SUBJECT: Wake/Franklin Counties; US 401 (Rolesville Bypass) from NC 96 to SR 1103; Federal Aid No. STP-401(249); State Project 8.1403001; WBS # 34506.1.1; **TIP R-2814C.**

Attached are the most recent modification of the US Army Corps of Engineers Individual Permit, N.C. Division of Water Resources (NCDWR) Water Quality Certification, and Neuse & Tar Pamlico Buffer Authorization. All environmental permits have been received for the construction of this project.

Subject: Modification to the 401 Water Quality Certification Pursuant to Section 401 of the Federal Clean Water Act, NEUSE & TAR-PAMLICO BUFFER RULES, and ISOLATED WETLANDS PERMIT Pursuant to IWGP100000 with ADDITIONAL CONDITIONS for Proposed improvements to US 401 in Wake & Franklin Counties, Federal Aid Project No. STP-401(249), State Project No. 81403001, TIP R-2814C NCDWR Project No. 20090104 ver. 6

PERMIT DRAWING
SHEET 46 OF 61

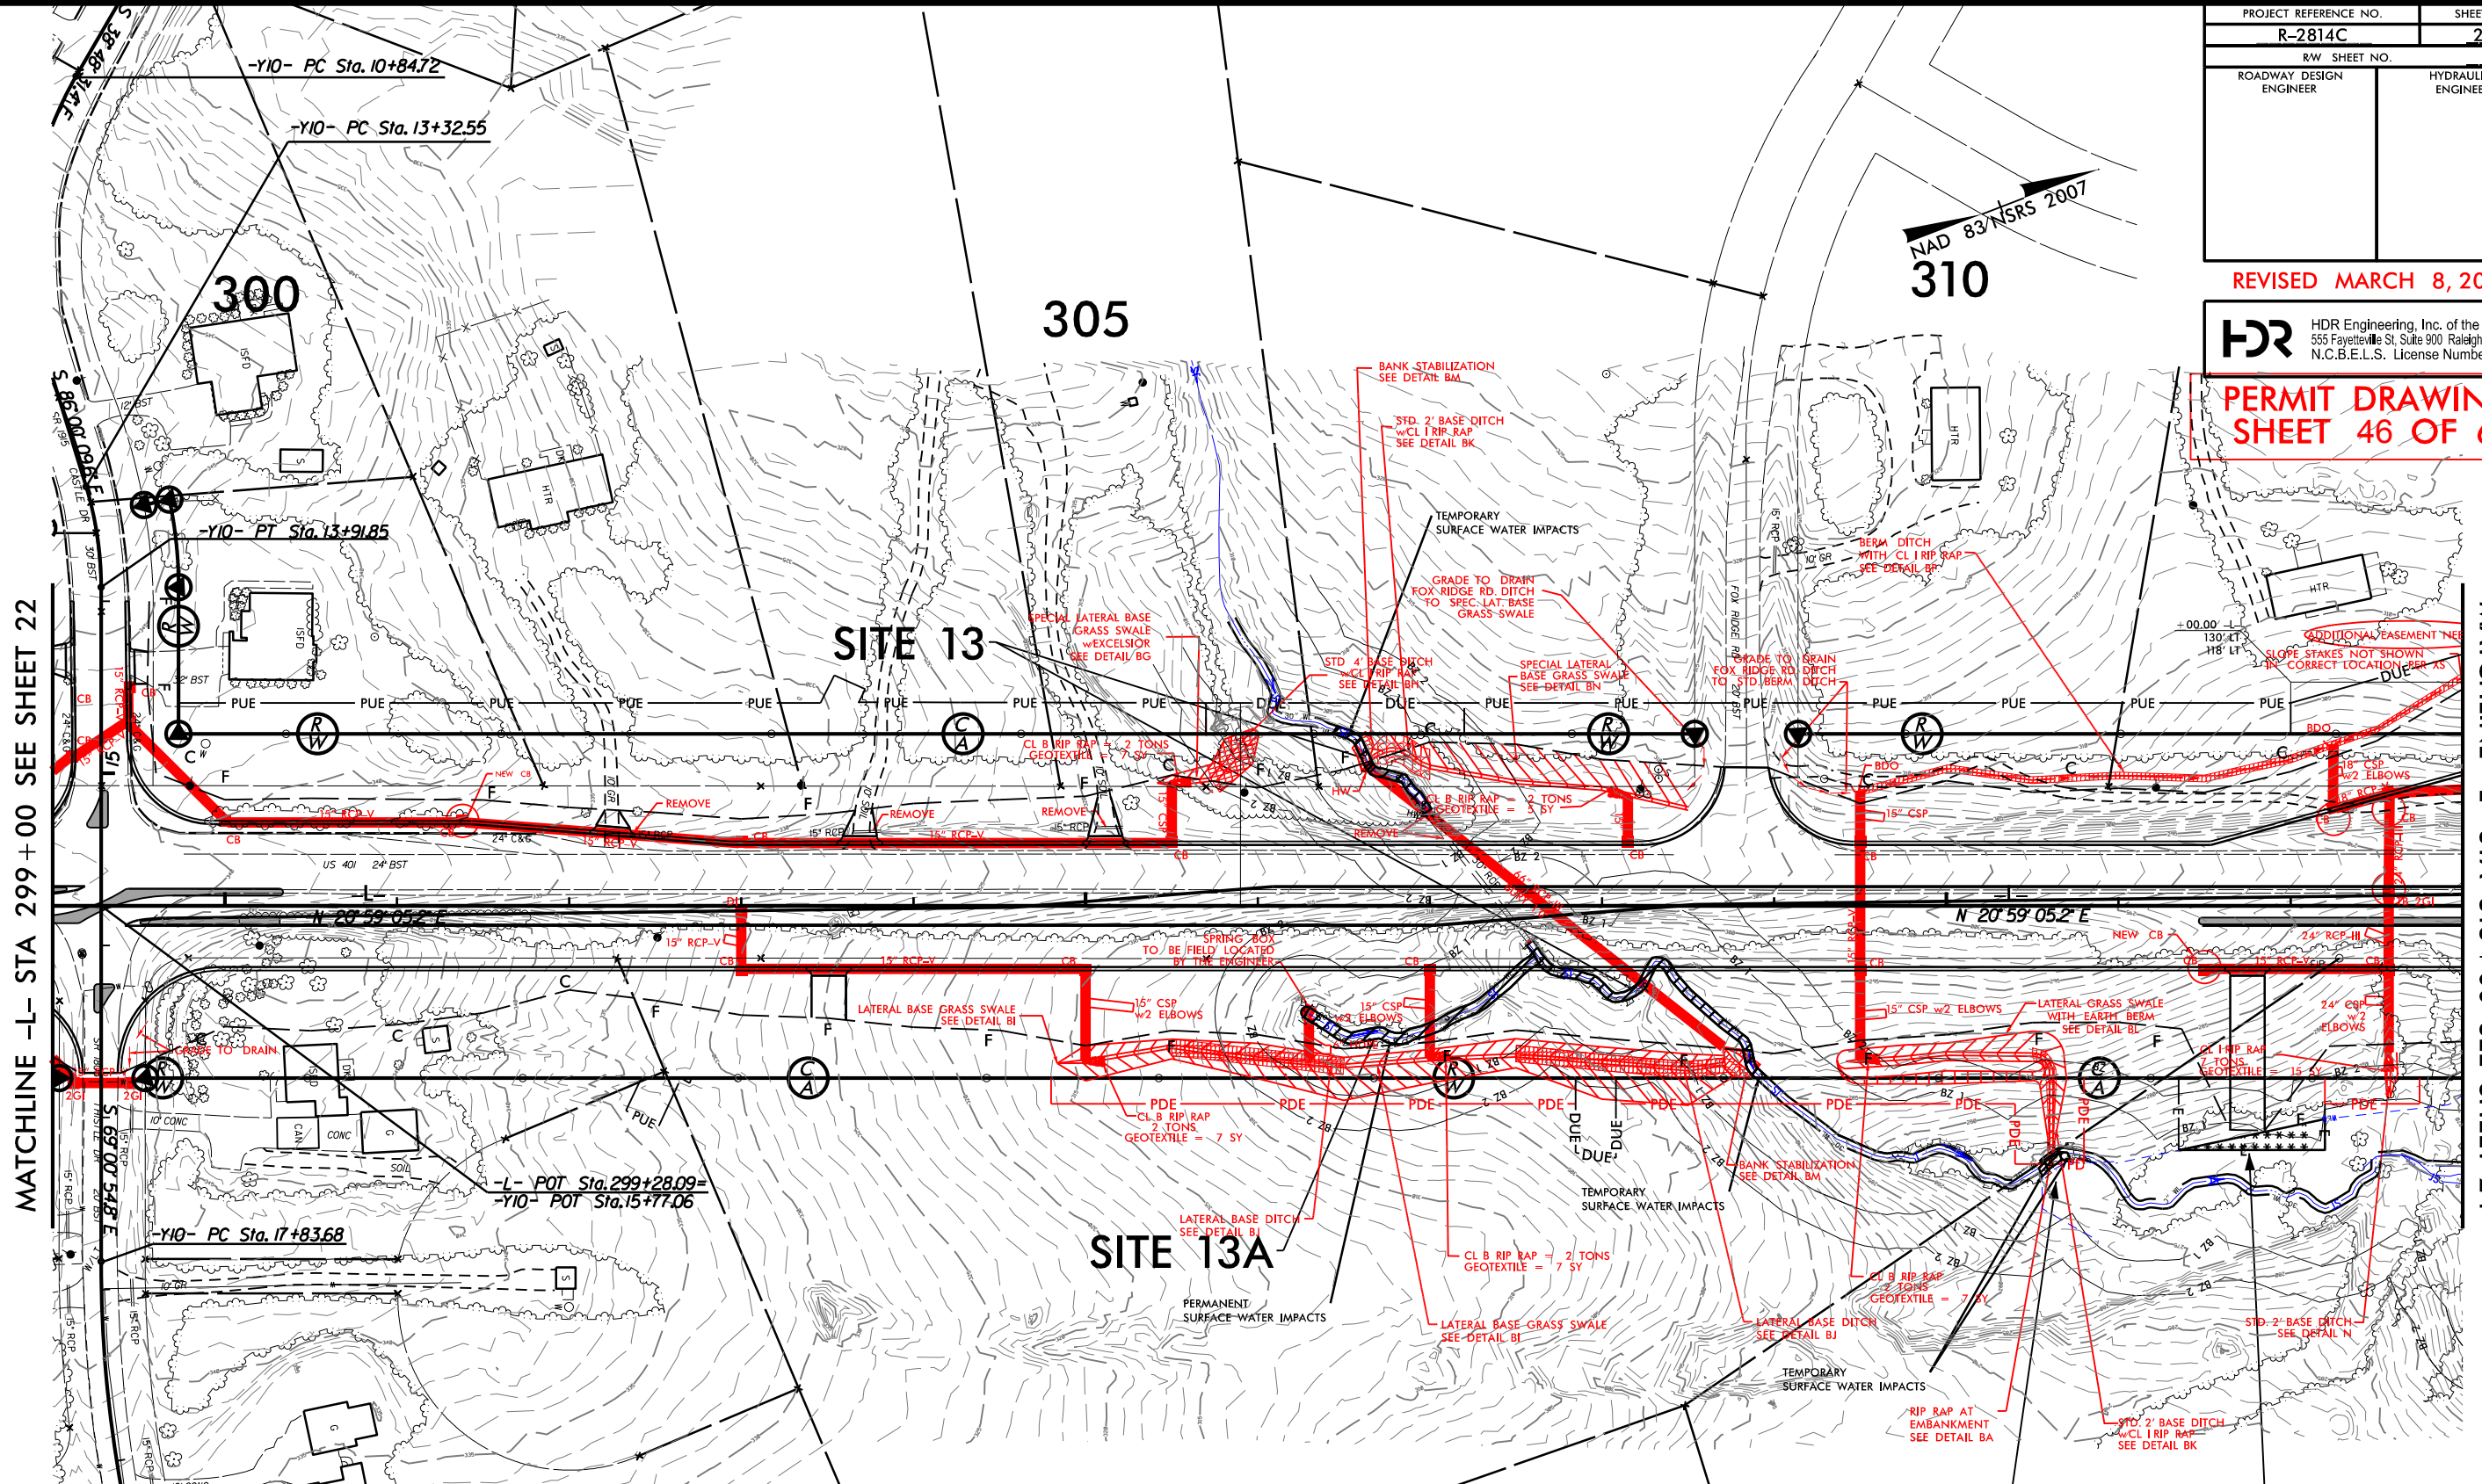
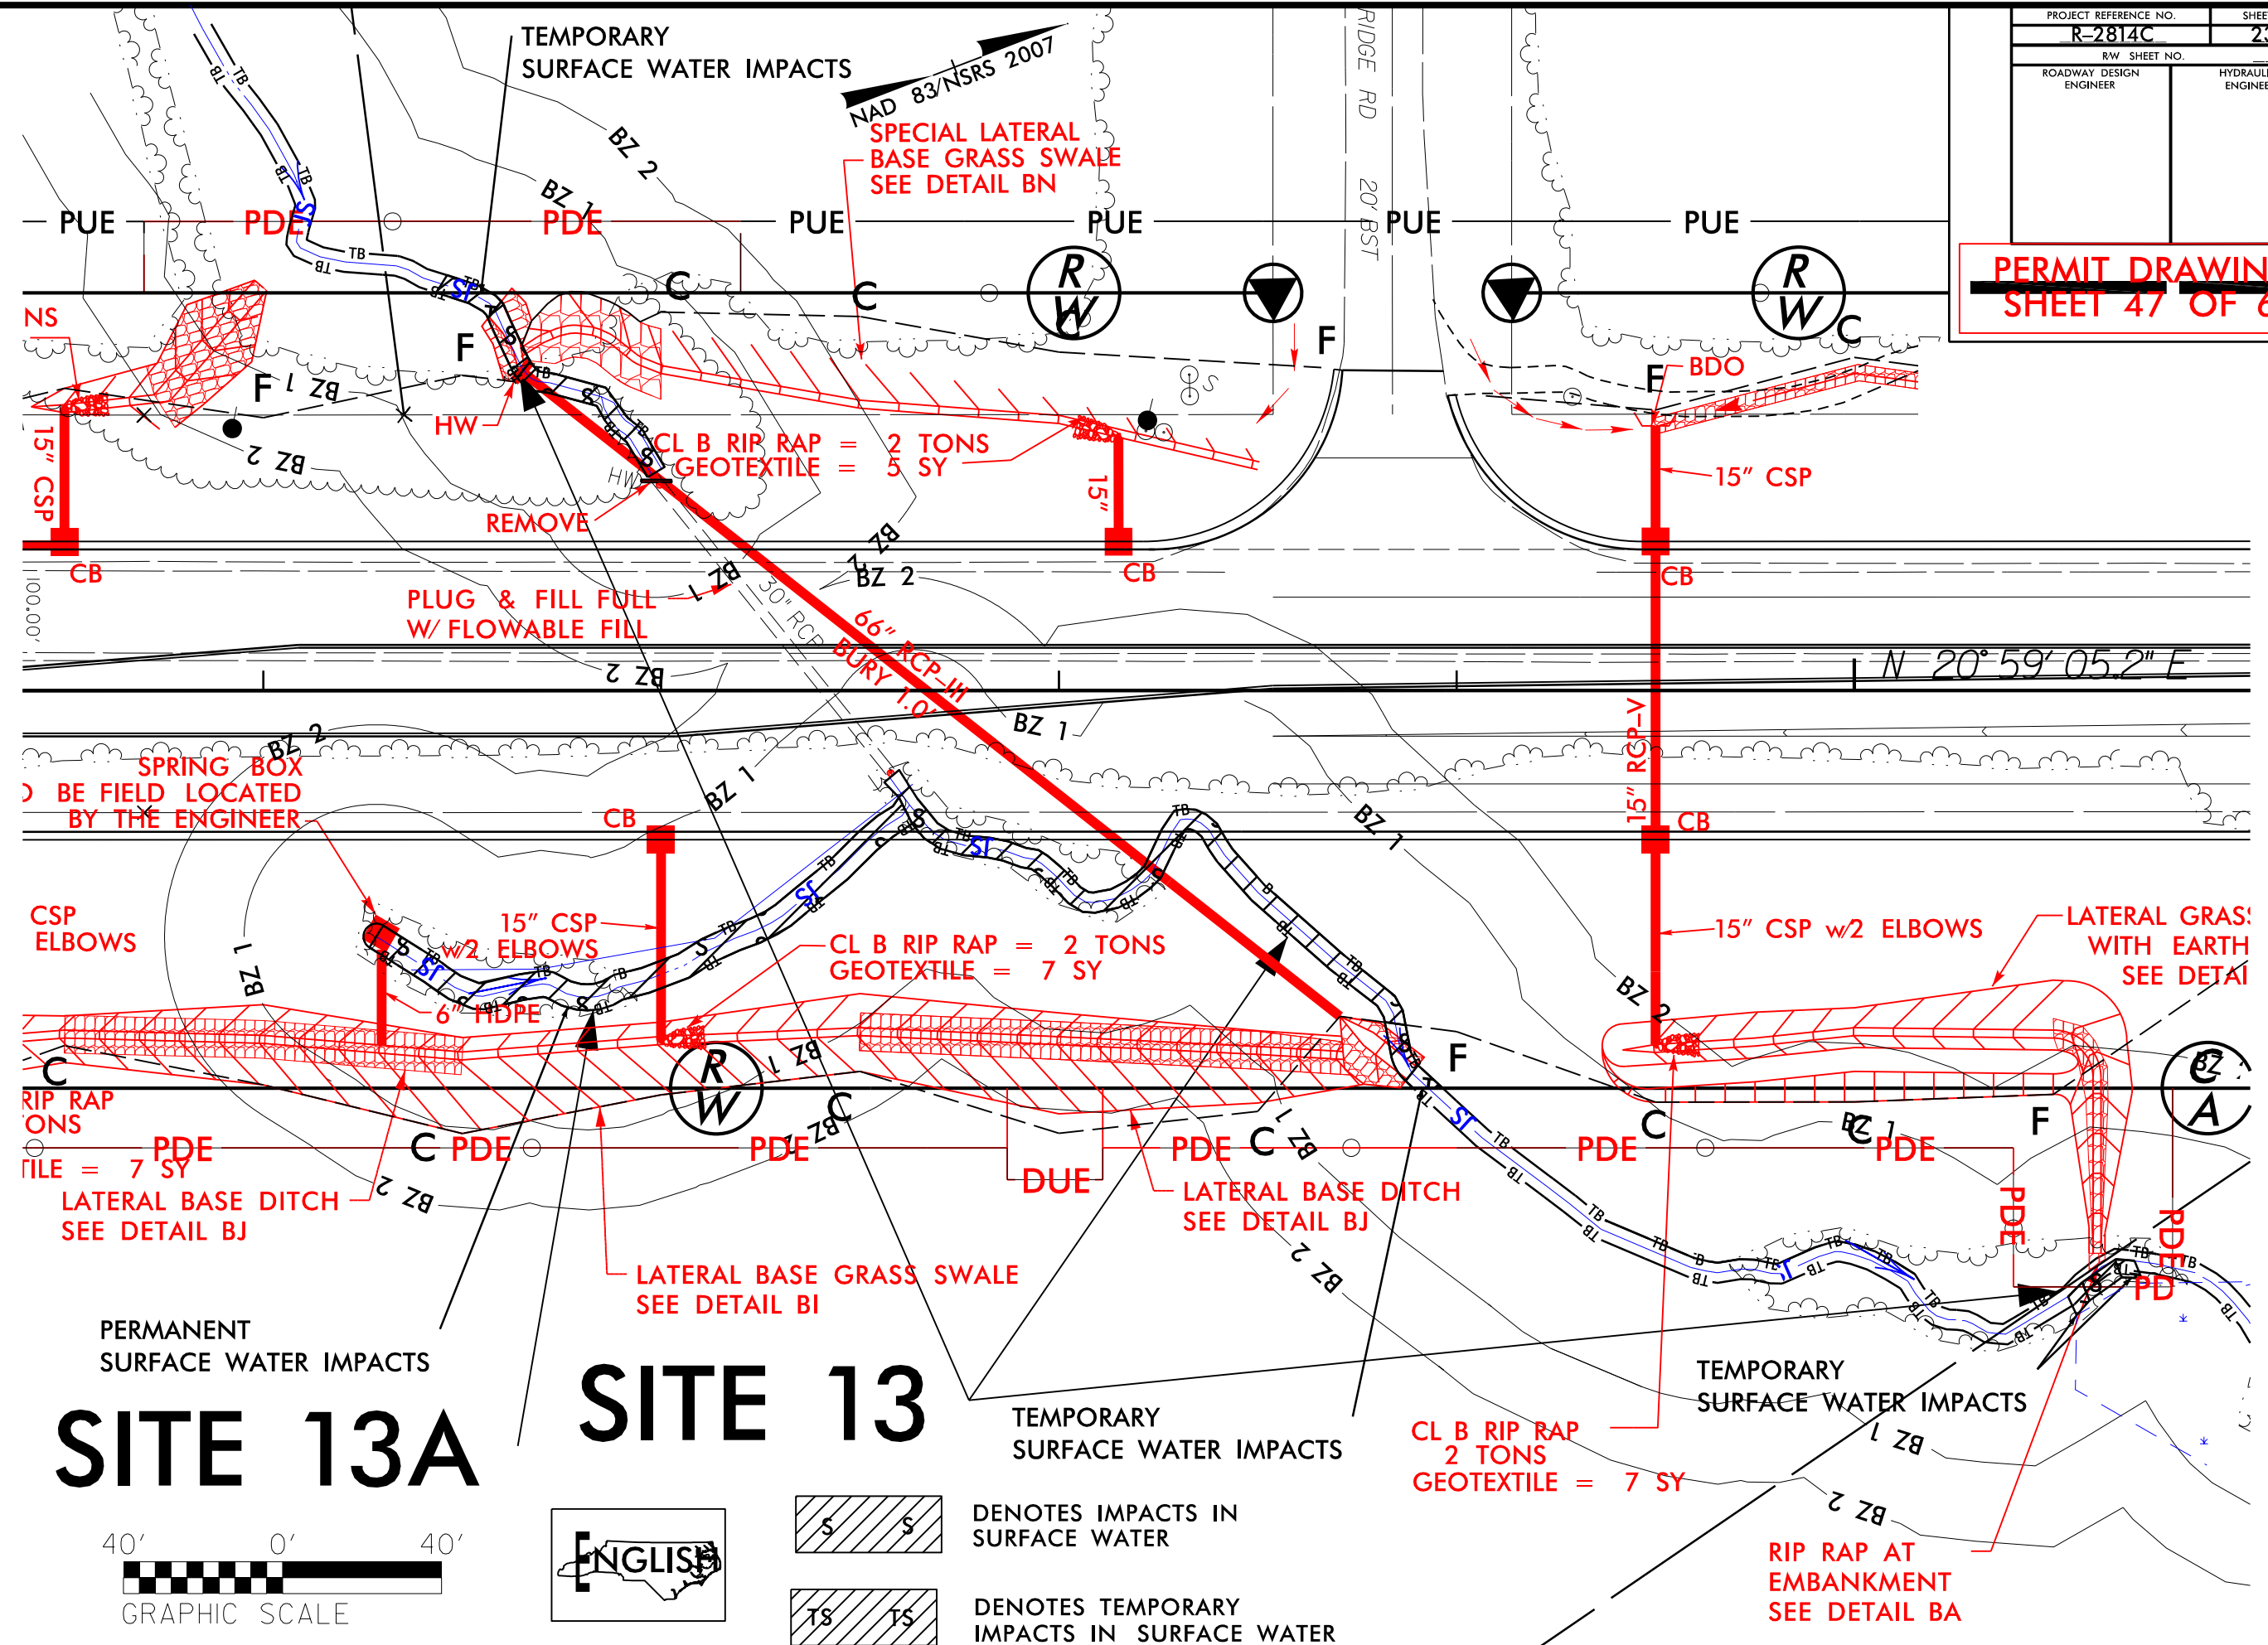
MARCH 9, 2018 REVISION INCLUDES
NEW SITE 13B ADDED FOR NEW DRIVEWAY

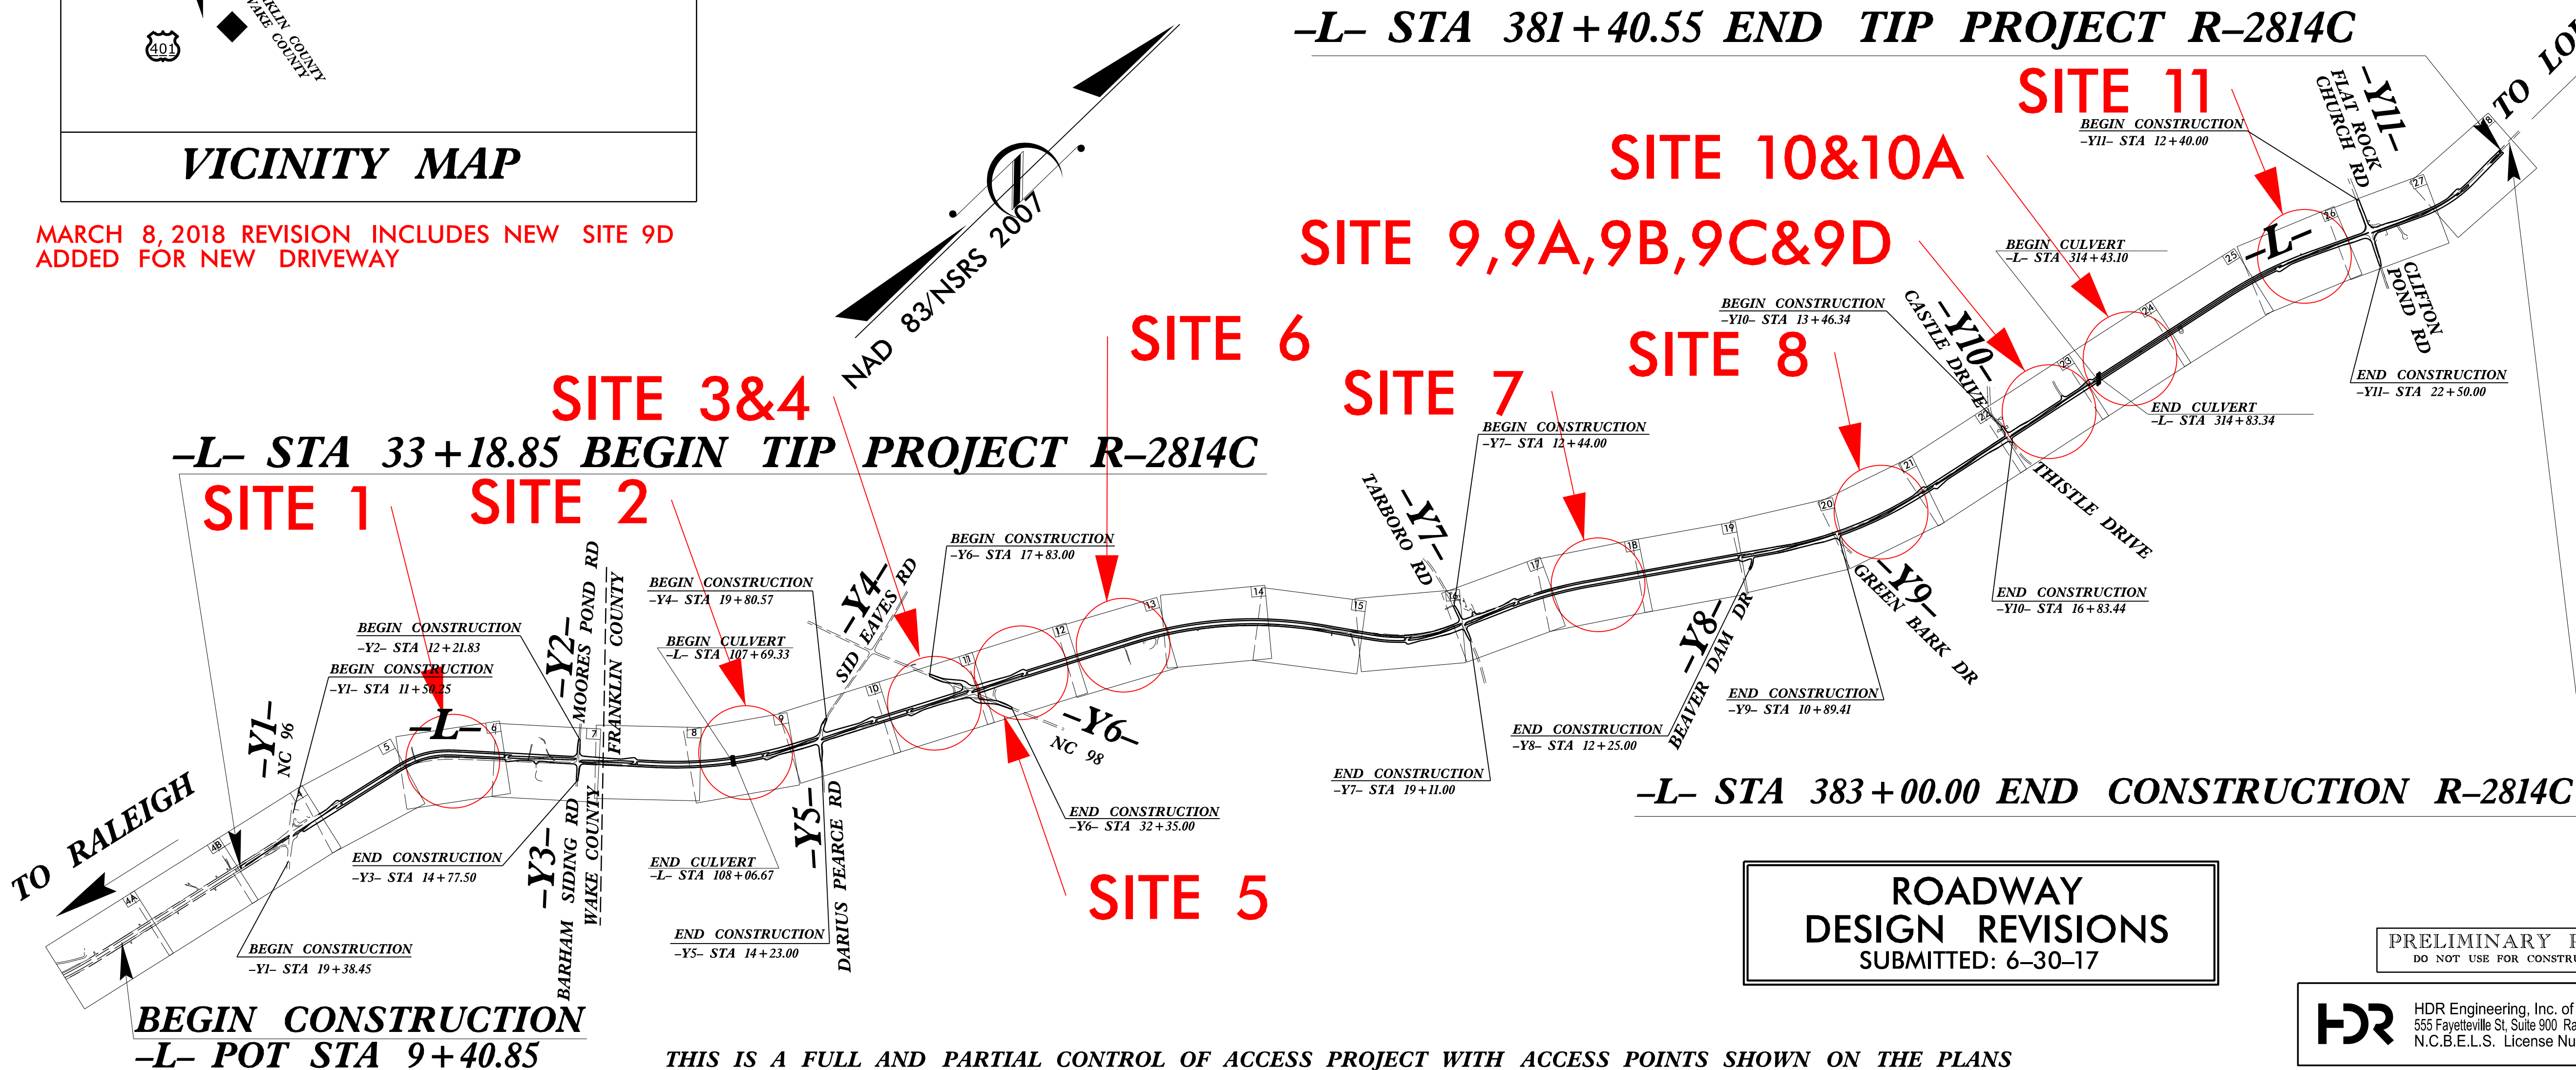
MARCH 8, 2018 REVISION INCLUDES NEW SITE 9D
ADDED FOR NEW DRIVEWAY
